REMARKS/ARGUMENTS

This letter is responsive to the Office Action dated August 14, 2002. This response is accompanied by a request for a one-month extension of time. Accordingly, this response is timely filed.

"VERSION WITH MARKINGS TO SHOW CHANGES MADE"

FIG. 3

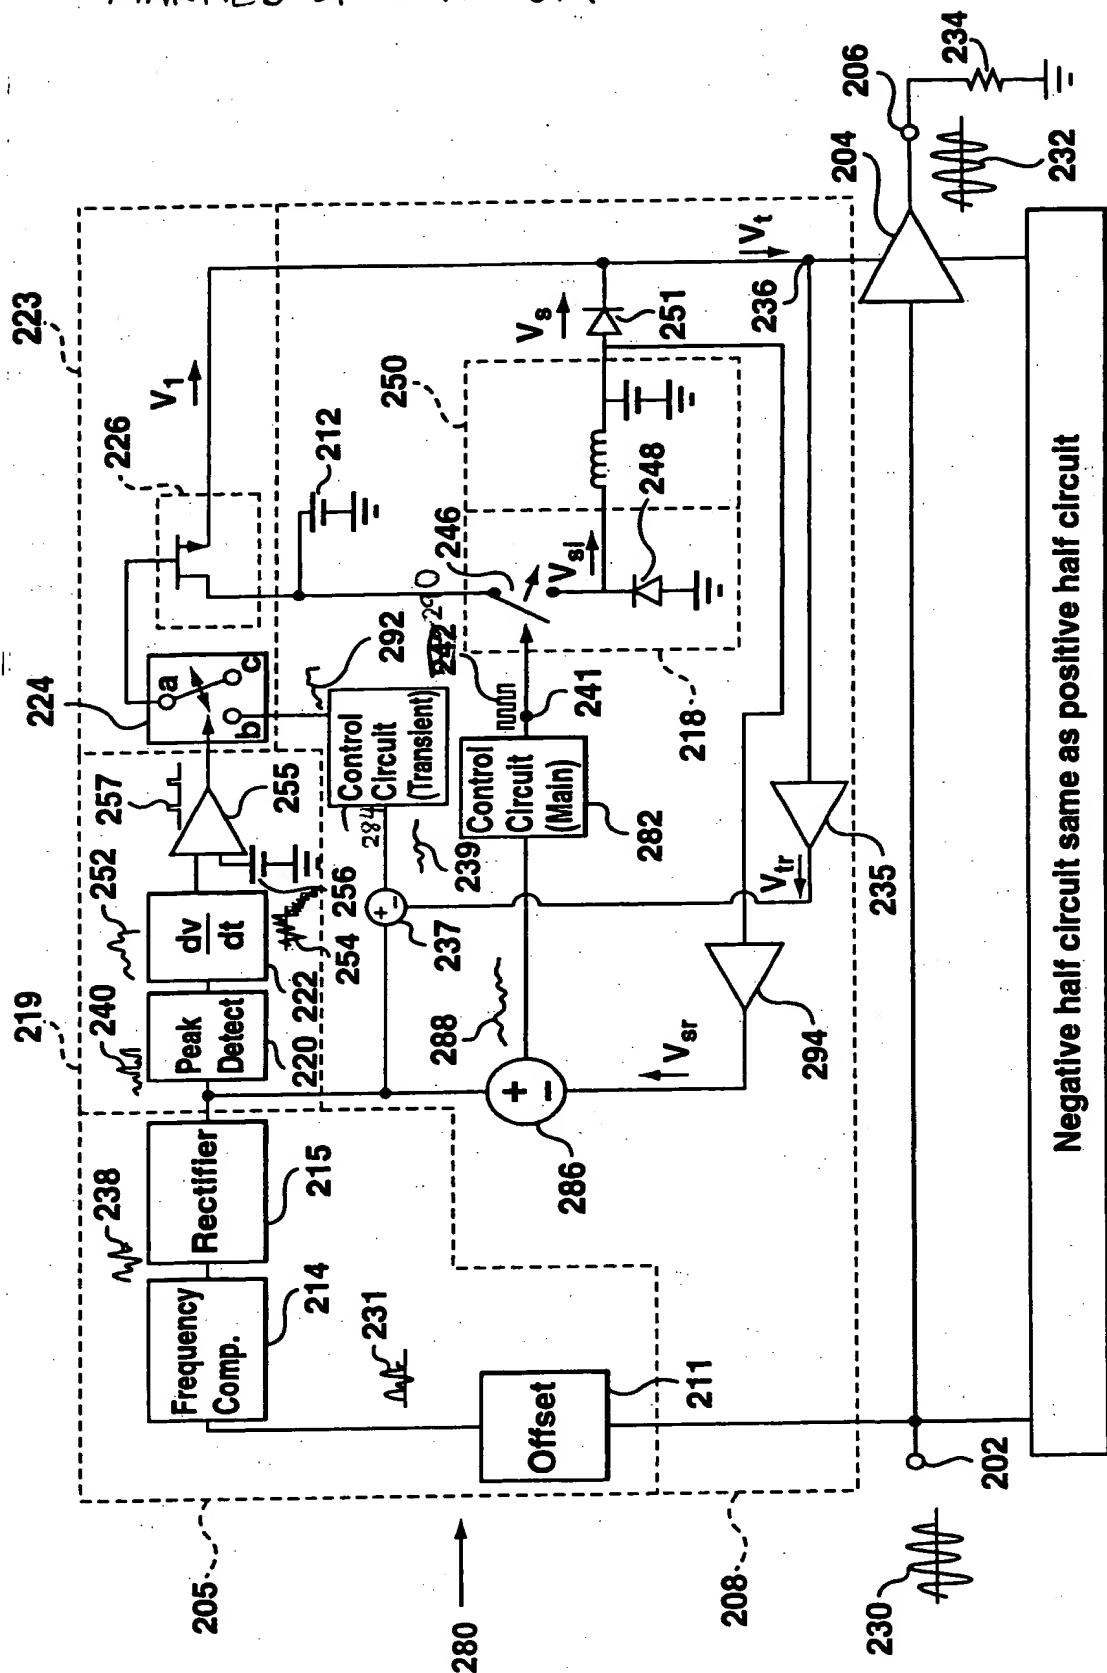
In particular, the Applicant has amended Figure 3 to label the control circuit with reference numeral 284 and to correctly label the control signal with reference label 290 rather than reference label 242. The Applicant has amended Figure 5

FIG. 5

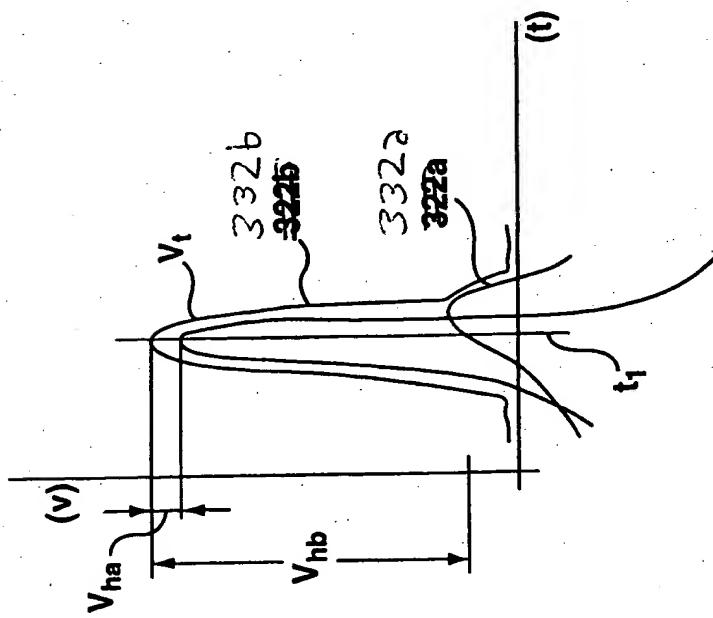
to correctly label the output signals with reference labels 332a and 332b rather than reference labels 322a and 322b. The Applicant has also amended Figure 6 to add the error signal 239.

FIG. 8

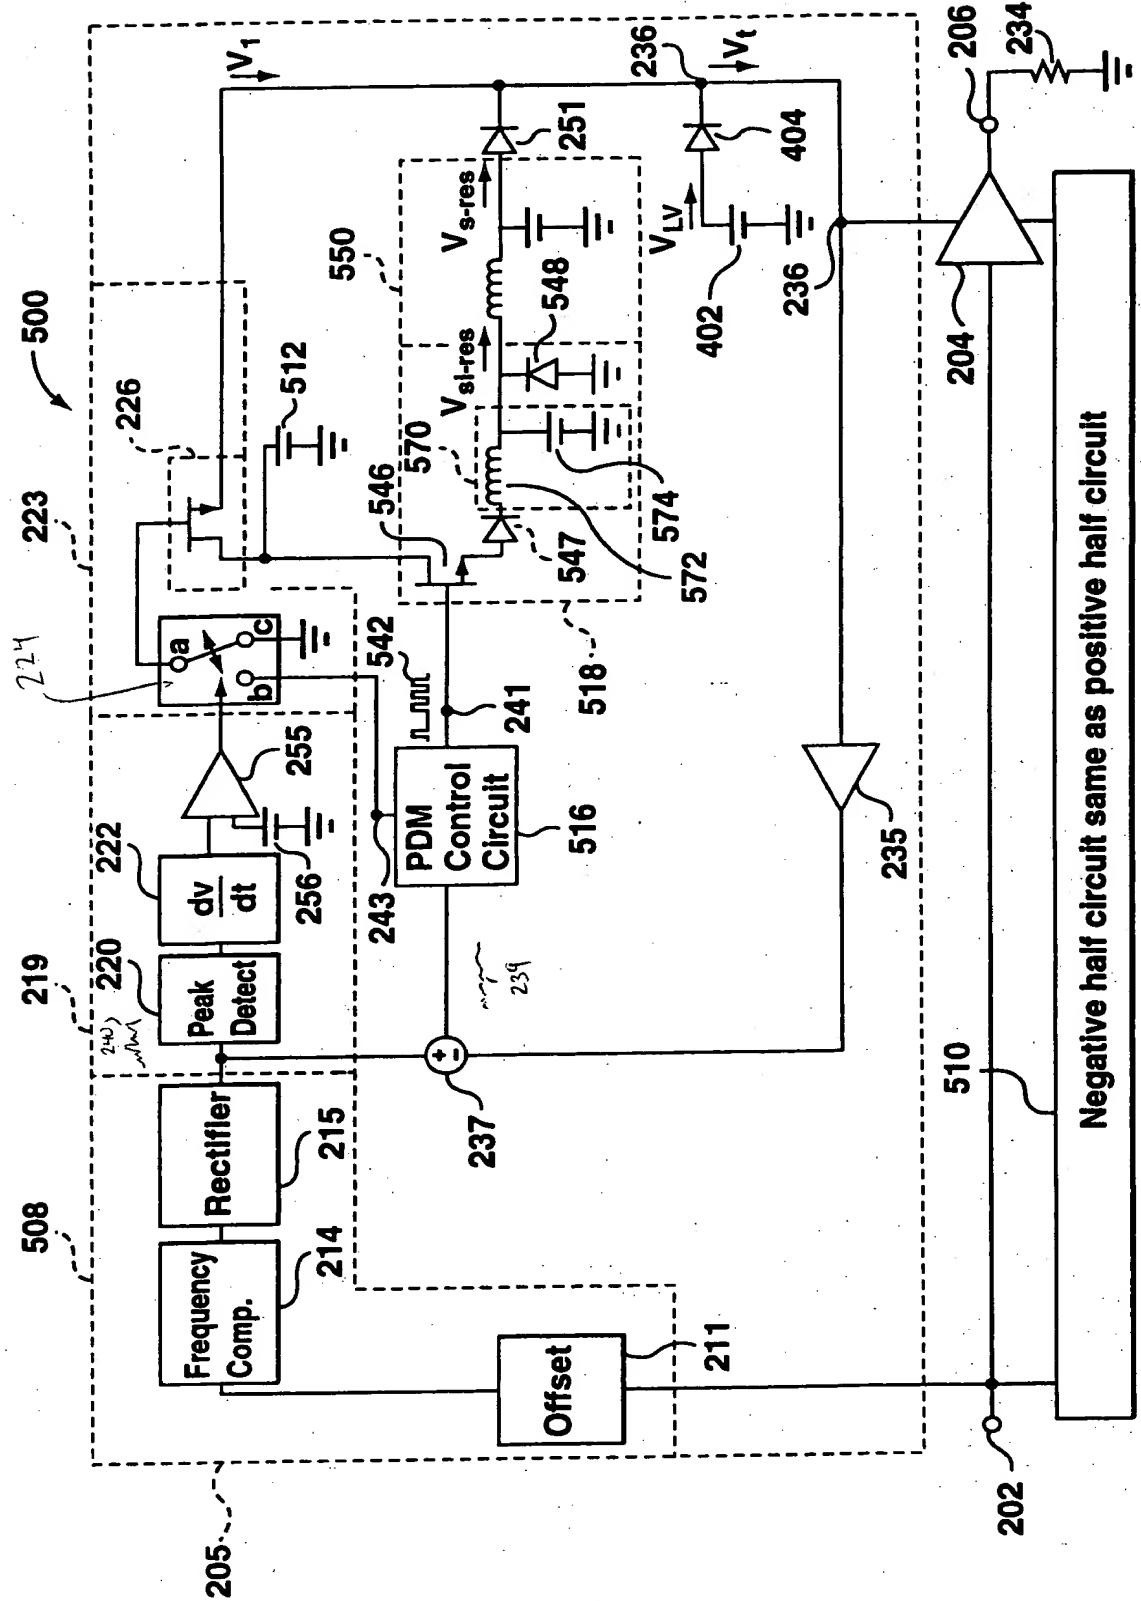
In addition, the Applicant has amended Figure 8 to label the switch with reference label 224 and to include the error signal 239 and the rectified signal 240. The Applicant has amended Figure 10 to label the switch with reference label 224. The Applicant has amended Figure 11, to indicate that there is a capacitor C_9 located between the capacitor C_2 and the resistor R_{10} . Support for this amendment is in paragraph 114 of the application as filed. In addition, the base of transistor Q_9 has been connected between resistors R_{13} and R_{14} . Support for this amendment is in paragraph 116 of the application as filed.

FIG. 14

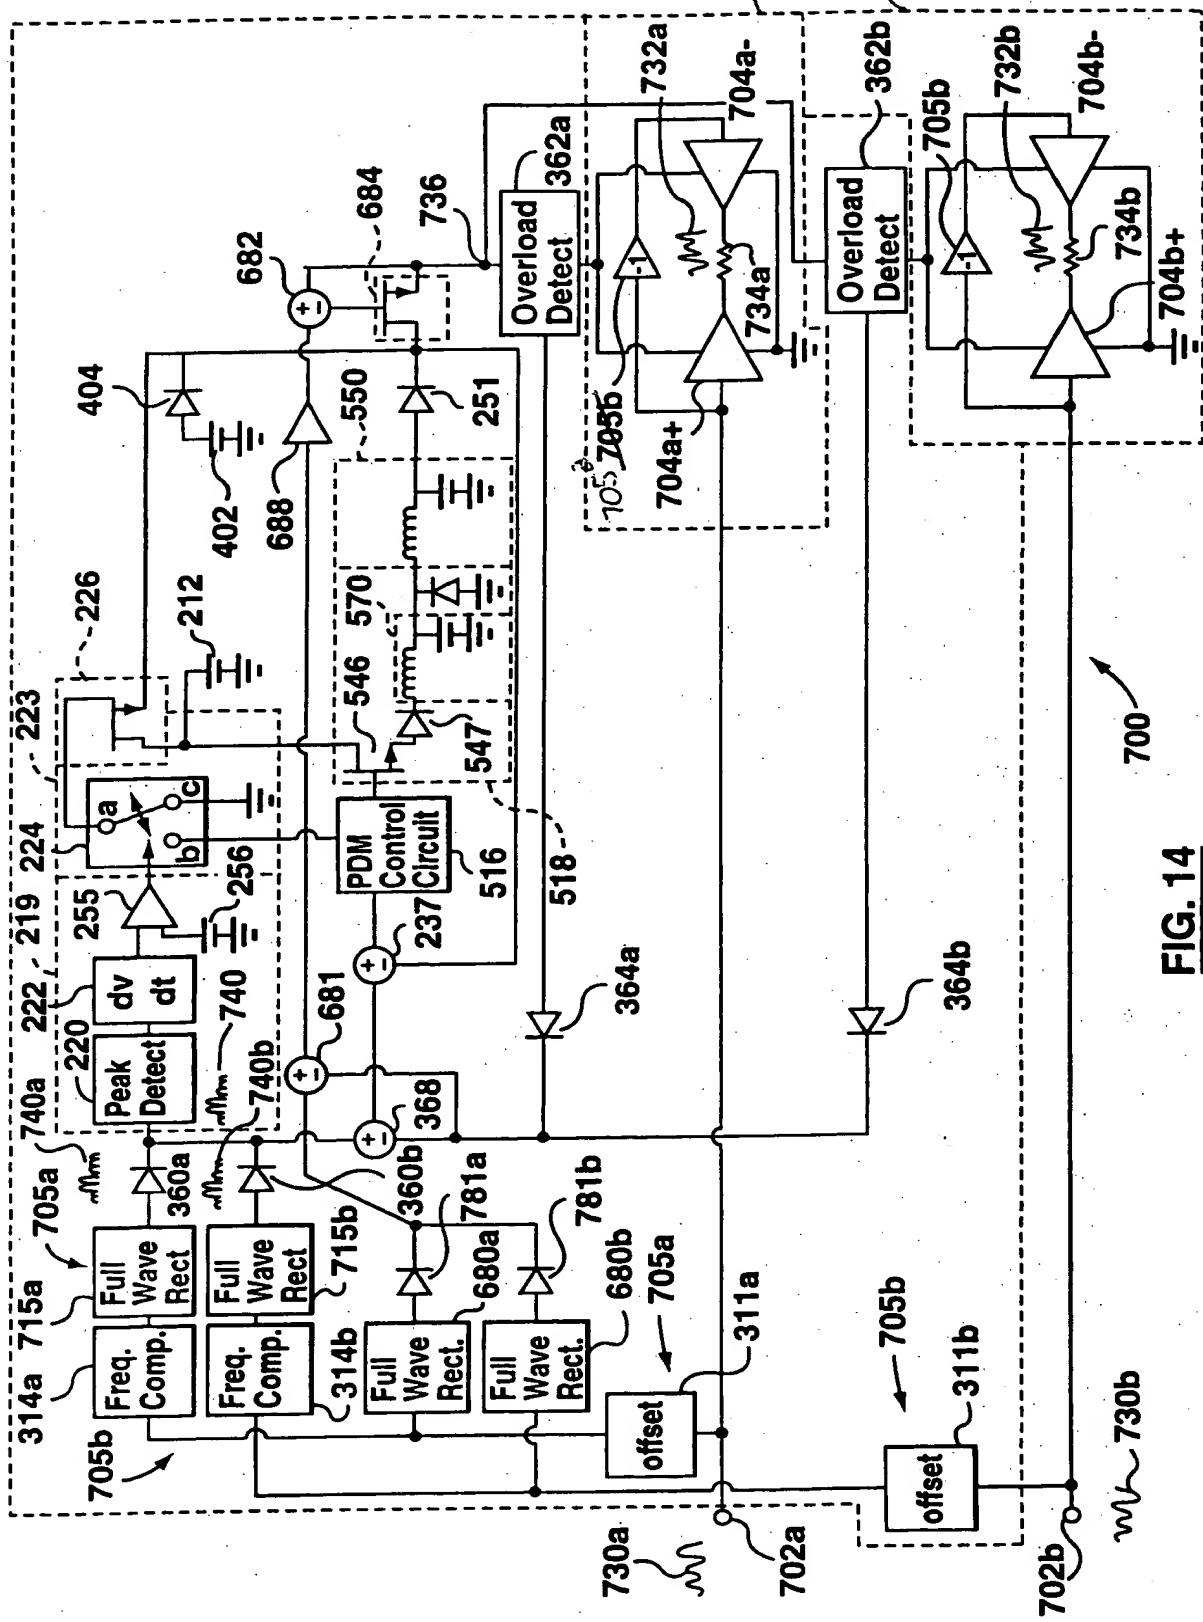
The Applicant has amended Figure 14 to replace reference label 705b with 705a and 709 with 709a respectively. The Applicant has also labeled the second bridge amplifier at the bottom of Figure 14 with reference label 709b. The Applicant has also amended Figure 15 to include reference label 204 for the amplifier connected to node 206, as well as reference labels 849a and 849b for the inputs of amplifier 820. The Applicant has also added reference label 812 to represent the chassis ground connected to capacitor 828, the positive input of amplifier 830 and the resistor 234. Support for these reference label amendments is in paragraphs 140-149 on pages 41-43 of the application as filed.

FIG. 16

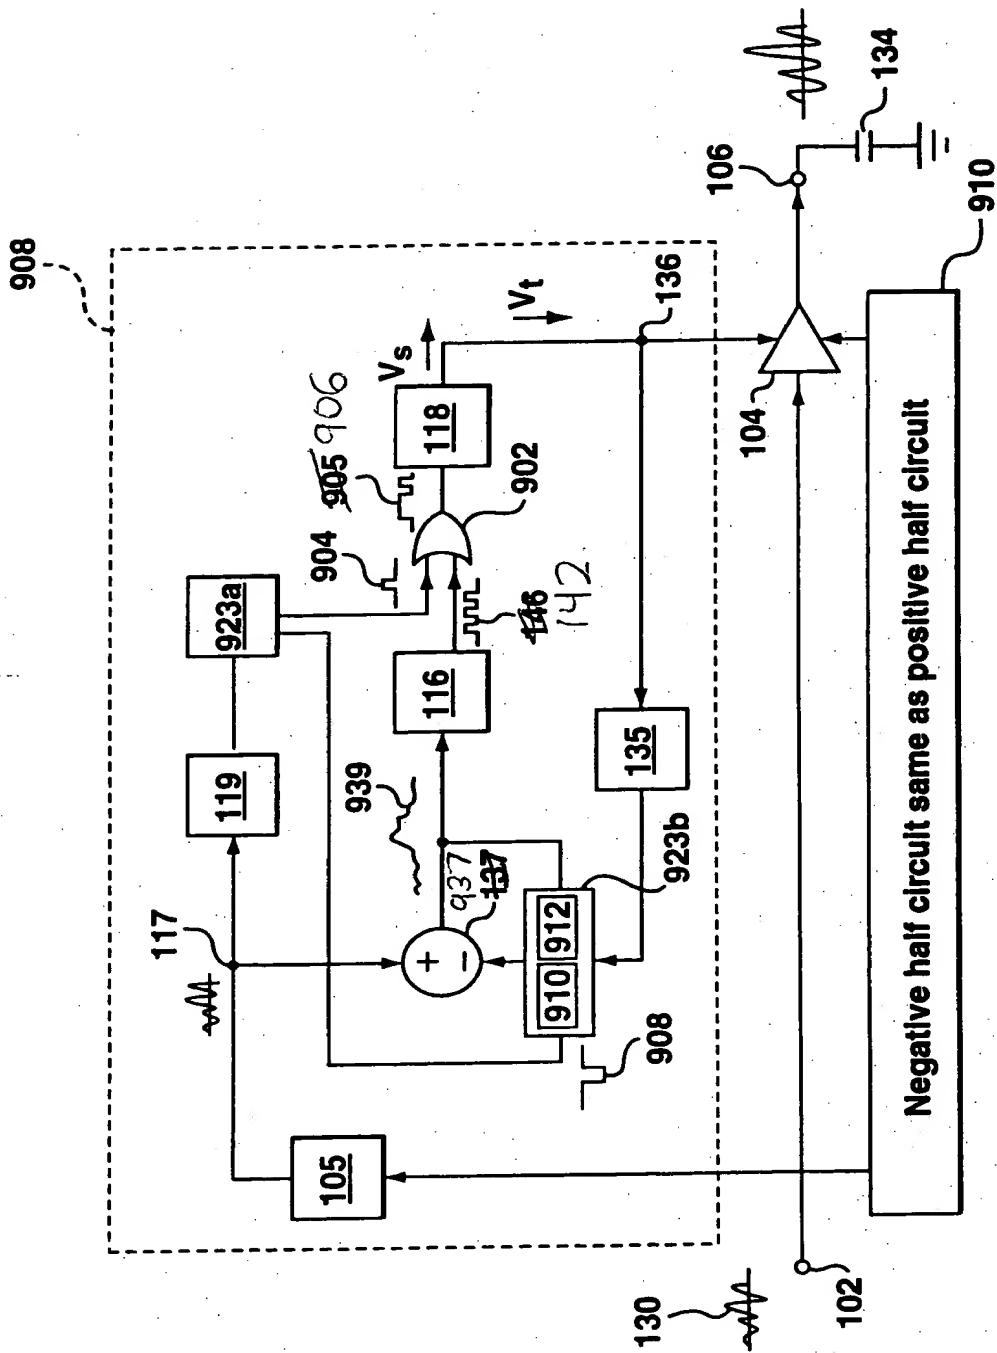
The Applicant has amended Figure 16 to correct incorrect reference labels. In particular, the reference labels 905, 146 and 137 have been replaced with the reference labels 906, 142 and 937 respectively. Support for these reference label amendments is in 150-155 on pages 44-46 of the application as filed. In addition, the Applicant has amended Figure 17 to add reference numeral 1044 to the capacitor connected to node 1054 and to add reference numeral 1040 to the diode that is connected to node 1056. Support for these reference label amendments is in paragraph 159 on page 47 of the application as filed.
